Charlotte Historic District Commission

Agenda Supplement

September 10, 2025

3. 3105, 3109, 3113, 3117, 3121 Colyer PI (PID 09506133, 09506134, 09506135, 09506136, & 09506137)

PROPOSED POST CONSTRUCTION CHANGES WEST ELEVATION

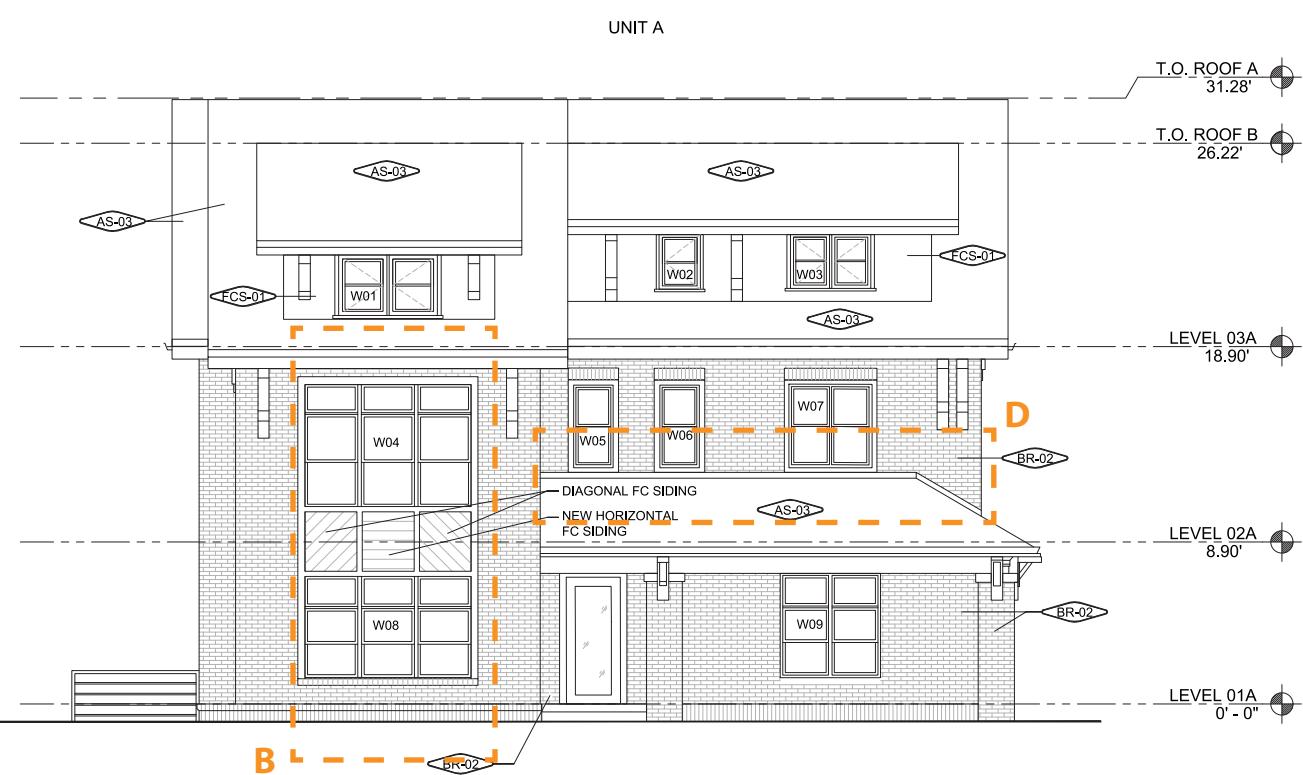
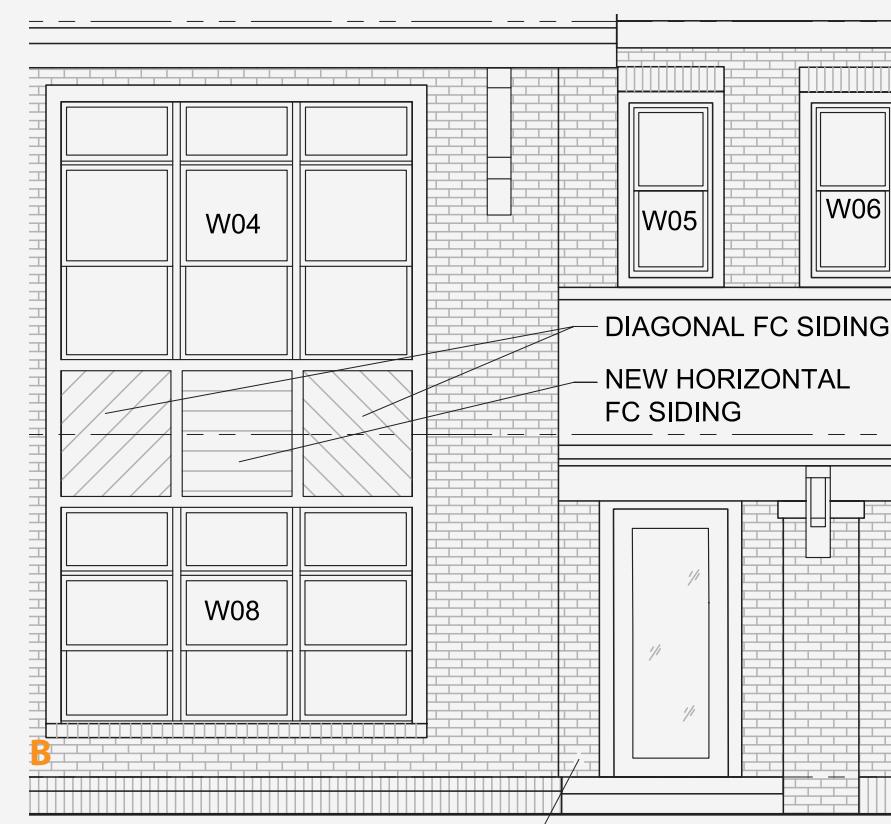
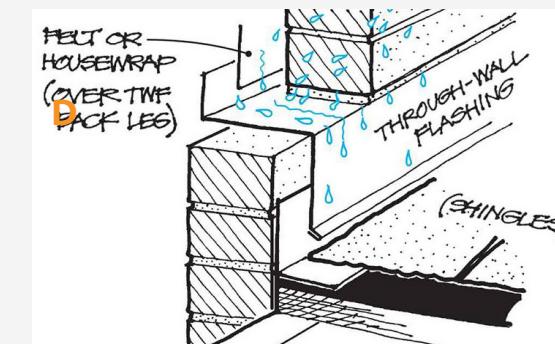
- c. The brick sill on above the front porch roof of Unit 3105 is still covered with flashing, and no alternative has been proposed. – As explained in the presentation, The depth of flashing at masonry walls is minimally sized in the vertical direction to provide adequate protection from water intrusion and is a typical detail seen throughout Historic Districts on chimneys (step flashing) and porches based on current building technologies, manufacturers installation requirements and general best practices.

- B** **It is proposed** to modify the diagonal siding at these locations to allow for the three panel design approved in the COA documents. The three panels shall align with window mullions. The two outer panerls shall have diagonal siding to match the COA approved design intend and the new middle panel shall be infilled with a horizontally run siding to mathch the horizontal siding of the townhomes. The exposeddimensipoon of the siding dshall be consistent between the diagonal and horizontal panels.

- D Evaluating the brick flashing detail reveals the design initially presented and approved in the COA is not adequate to provide adequate water intrusion measures. The depth of flashing at masonry walls as installed is minimally sized in the vertical direction to provide adequate protection from water intrusion and is a typical detail seen throughout Historic Districts on chimneys (step flashing) and porches based on current building technologies, manufacturers installation requirements and general best practices. This detail will not be changed.

NOTE: a minimum of two brick courses are required to provide proper flashing and counter flashing from a brick head wall to a shingle roof.

1) Temporary Muntin, Design Standard 6.15

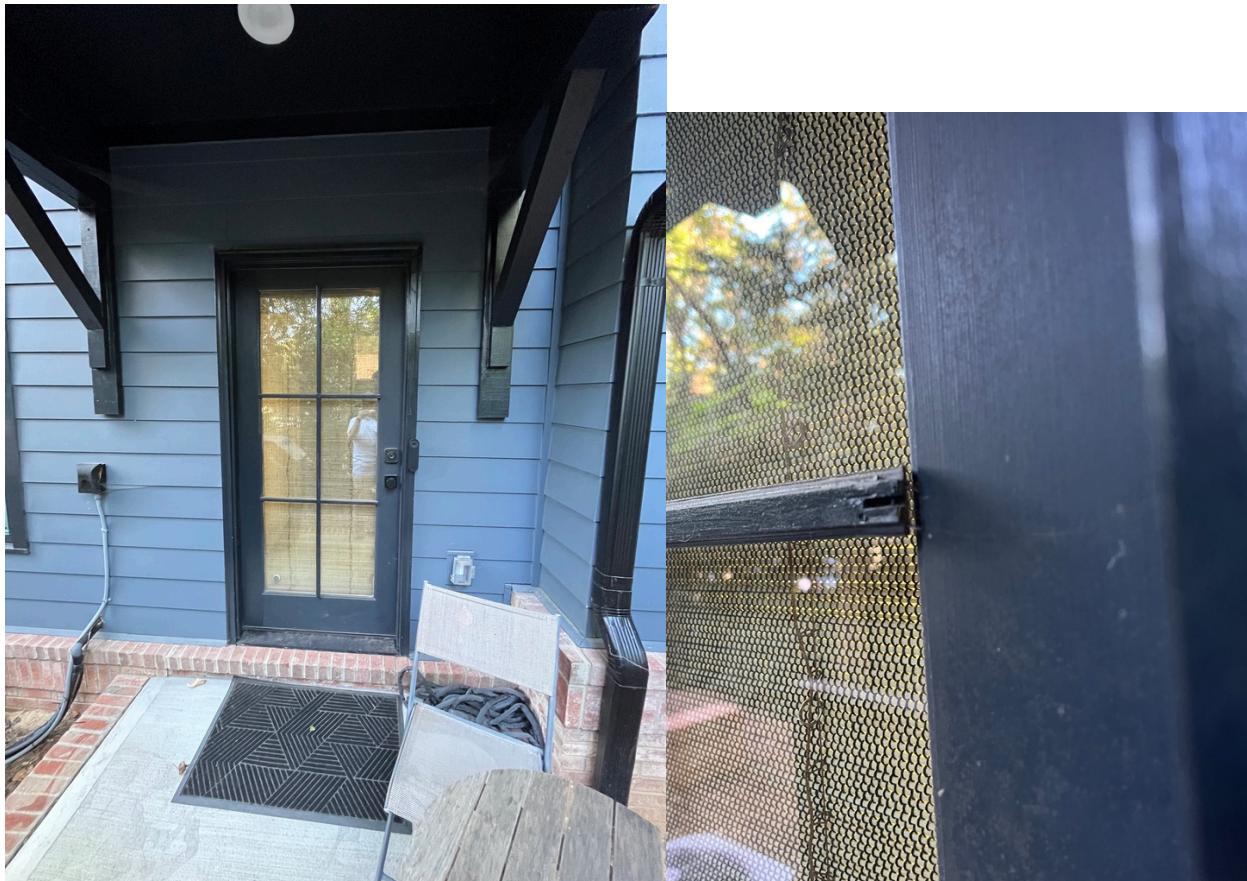
2. **Design Standard 6.15 – Temporary muntins:** On the east elevation of Building 4, the Applicant installed temporary muntins on entry doors, claiming they were required by the HDC. After reviewing [the standards](#), this does not appear correct, and these doors do not meet HDC requirements. Photos are enclosed for reference.

- 2) **Inconsistent Bracket Finishing, Design Standard 6.14.** Blue denotes the properly finished, black painted brackets. Red denotes gray un-finished brackets

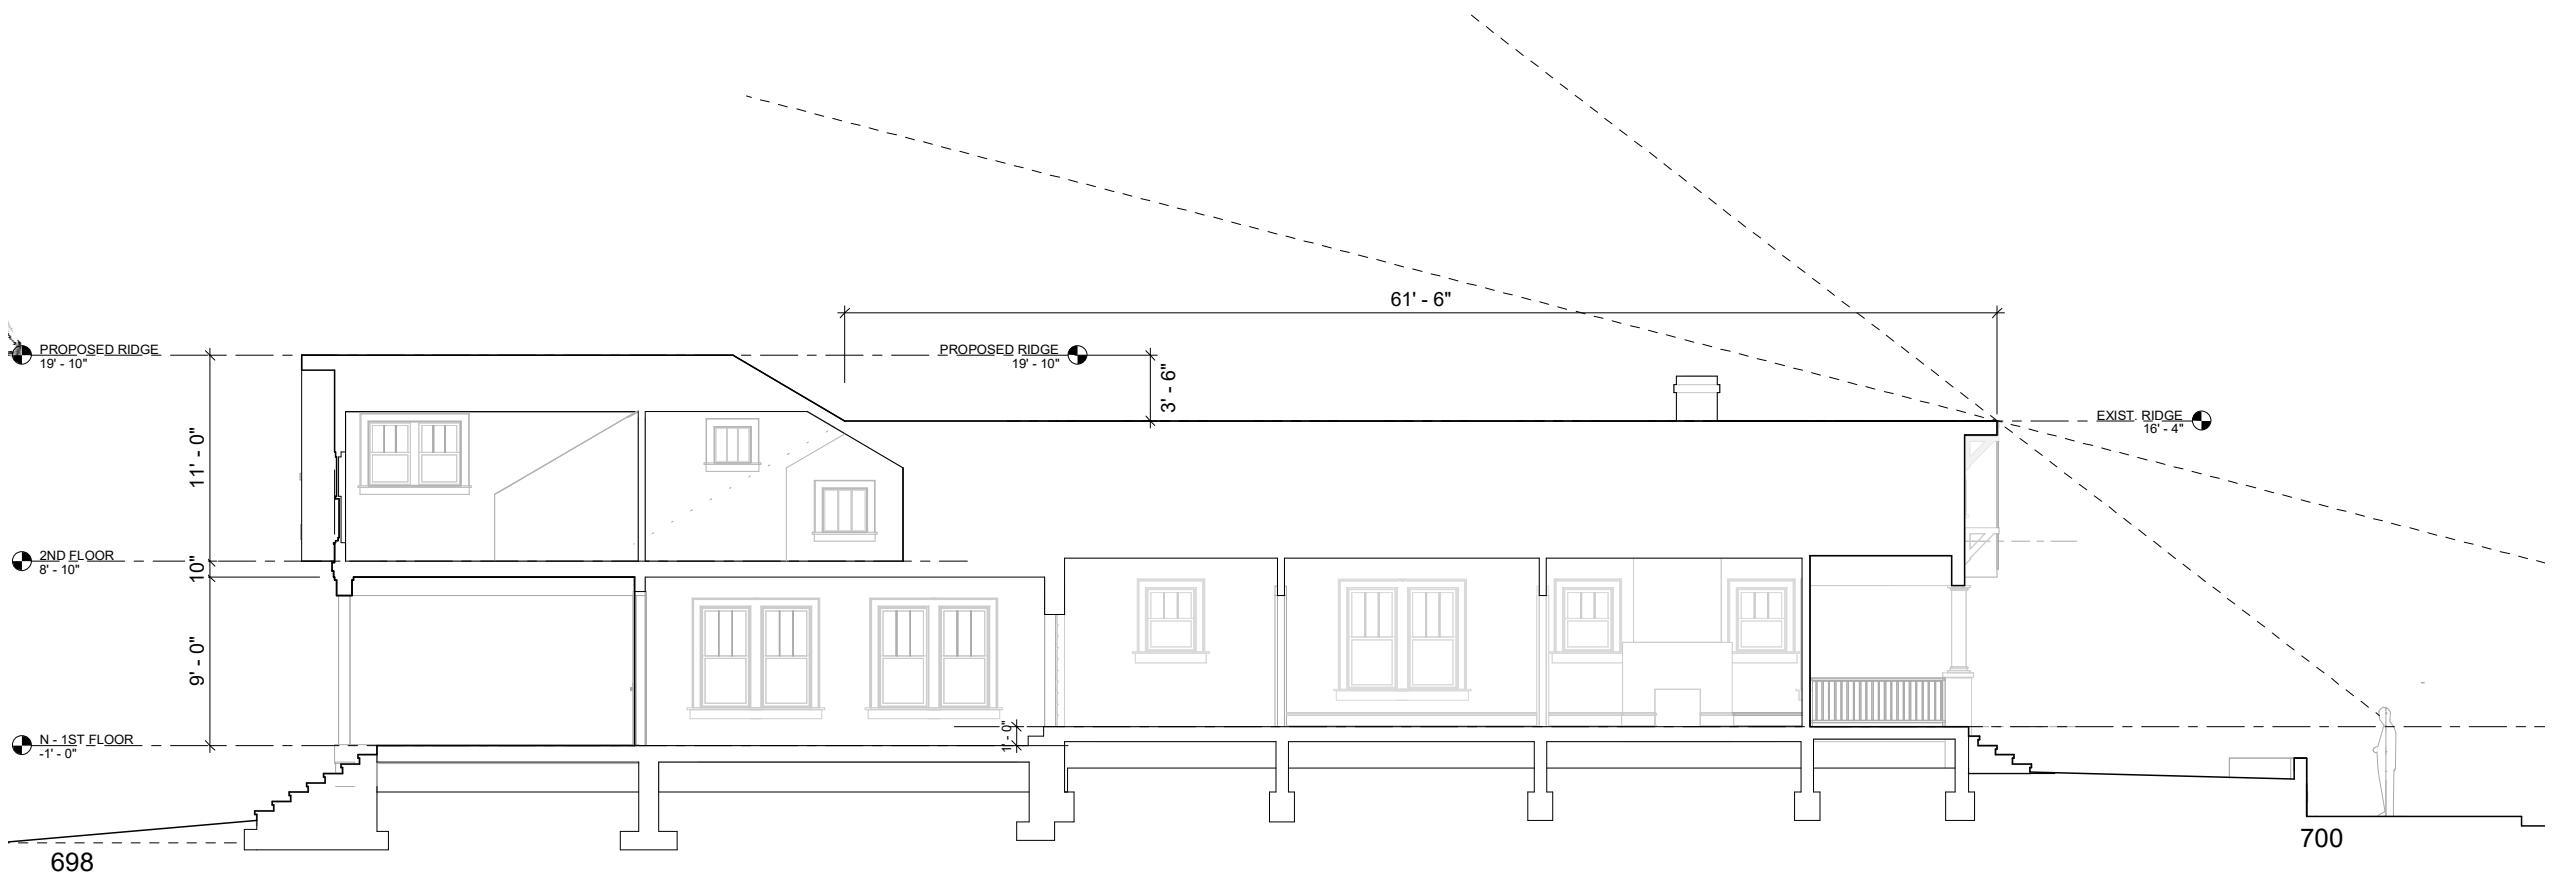
3. **Design Standard 6.14 – Bracket finishes:** In Building One (3105–3121 Colyer Place), many of the brackets identified in enforcement discussions are inconsistently finished—some are painted black while others remain gray and mismatched. Photos are enclosed. This inconsistency reflects a lack of attention to detail by the Applicant and further evidence of noncompliance with HDC standards.

House proposed to be stain/tinted. Existing brick.

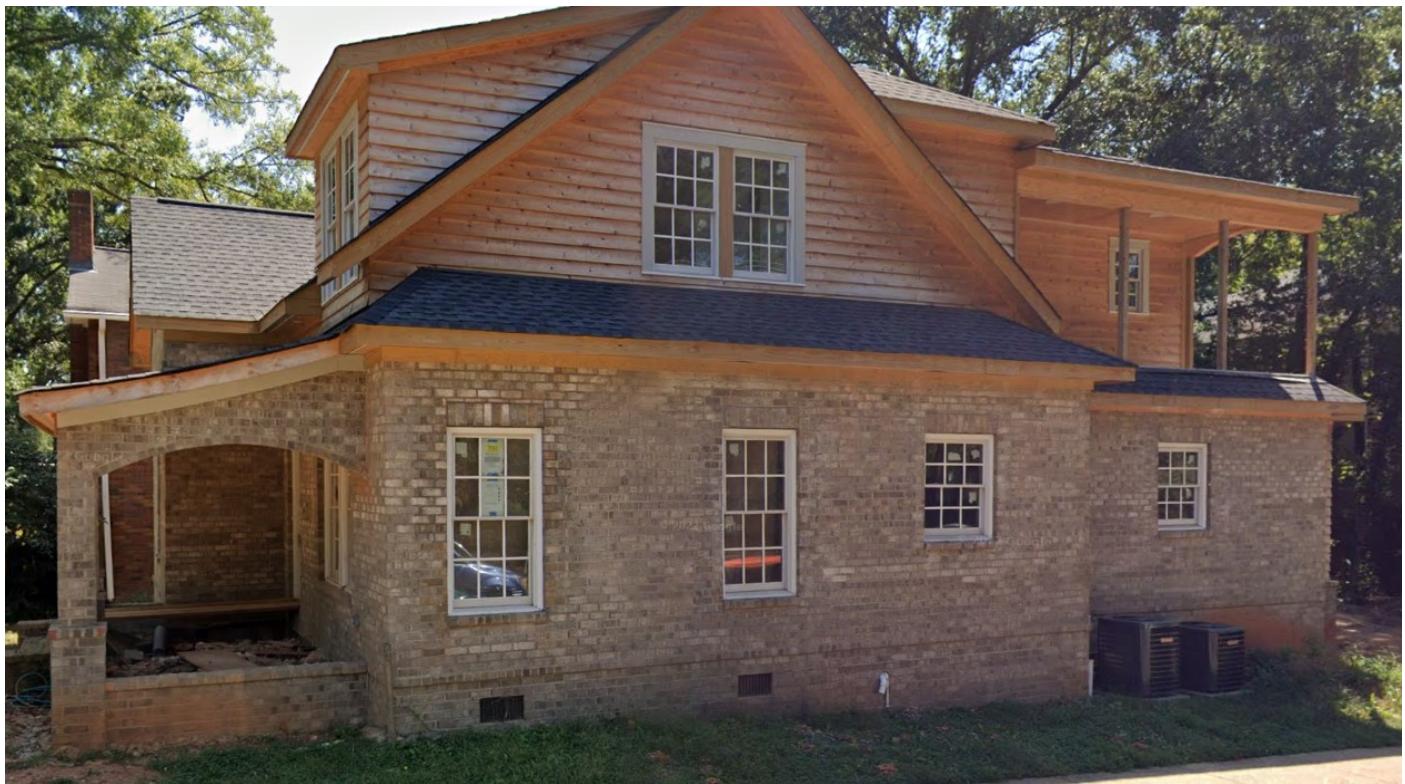
- What is the best Beeck product to stain/tint brick (red) and mortar (tan/light gray)?
- What is the vapor porosity of suggested product (stain/tint)?
 - Looking for the most breathable product.
- Does the color C-142 come in the suggested product (stain/tint)? (applicant's requested color)
- Does color C-142 best match the red brick house in the image below?
- What color would you suggest for mortar?

Based on your description this should be a good fit for our BEECK Concrete/Stone Glaze.

I have attached information on the product. It is more breathable than the brick masonry so it would not trap any moisture in the masonry.

Color is very difficult to pick from a photo, but I would suggest that they try our C-660 color thinned at a ratio of 1 part Beeck Concrete/Stone Glaze to 6 parts Beeck Base V Mixture.
